## ALERT SERVICE BULLETIN

**412CF-00-11**

Revision A, 22 April 2024

**SUBJECT:** CAP ANGLE, P/N 212-030-191-001, INITIAL INSPECTION

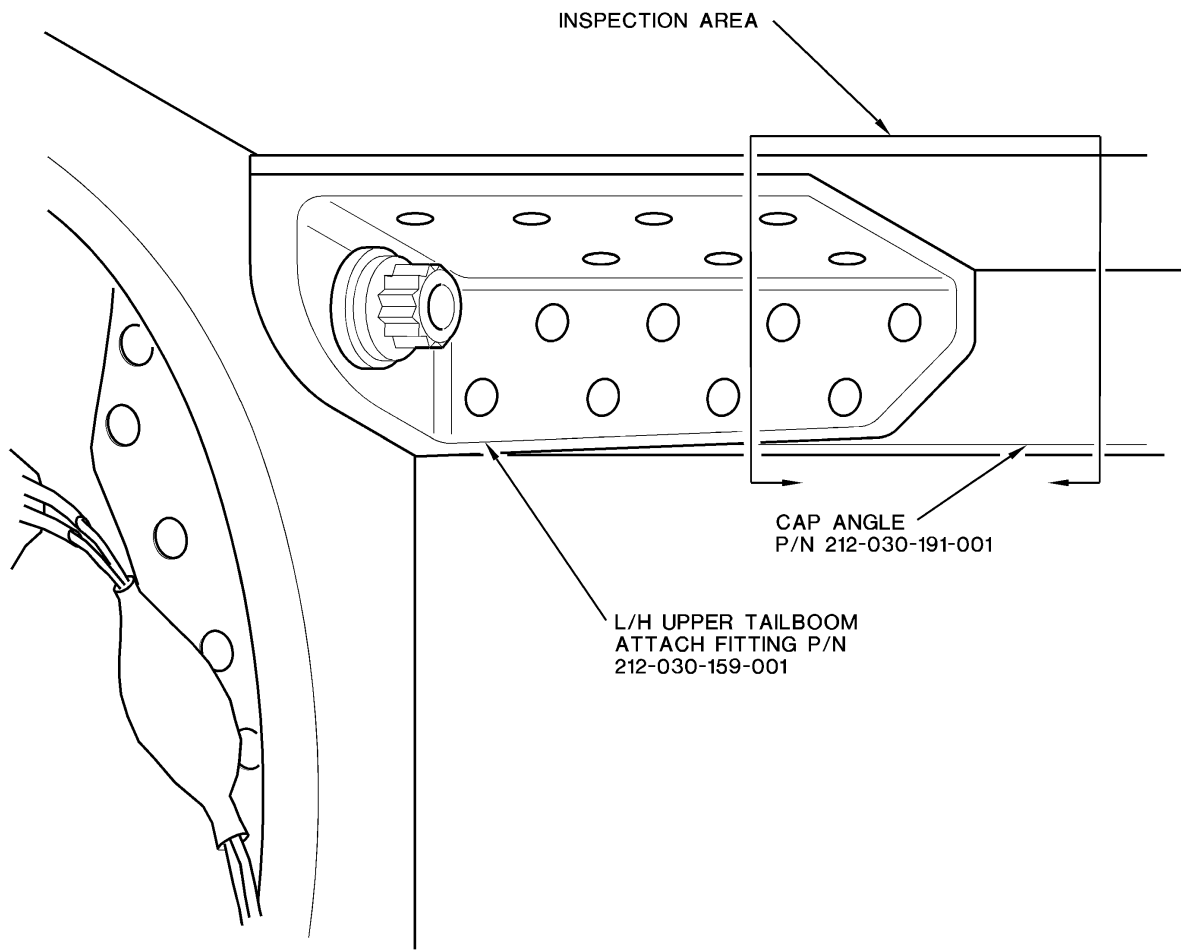
1. Gain access to the cap angle in the tail rotor servo compartment through the R/H aft fuselage door.
2. Inspect area noted on [figure 1](#) of cap angle, P/N 212-030-191-001, with 10x magnifying glass.
3. If no cracks are found, return the aircraft to service.
4. Revise C-12-146-000/MY-001 CH146 Maintenance Manual Scheduled 100 hour Inspection to include the following statement and copy of the figure 1: **“Inspect fuselage Tailboom attachment components and hardware for cracks with a 10X magnifying glass, pay particular attention to the interface between the end of the Tailboom attachment fitting and cap angle. Refer to figure 1.”**

5. If a crack is found, contact Product Support Engineering before further flight:
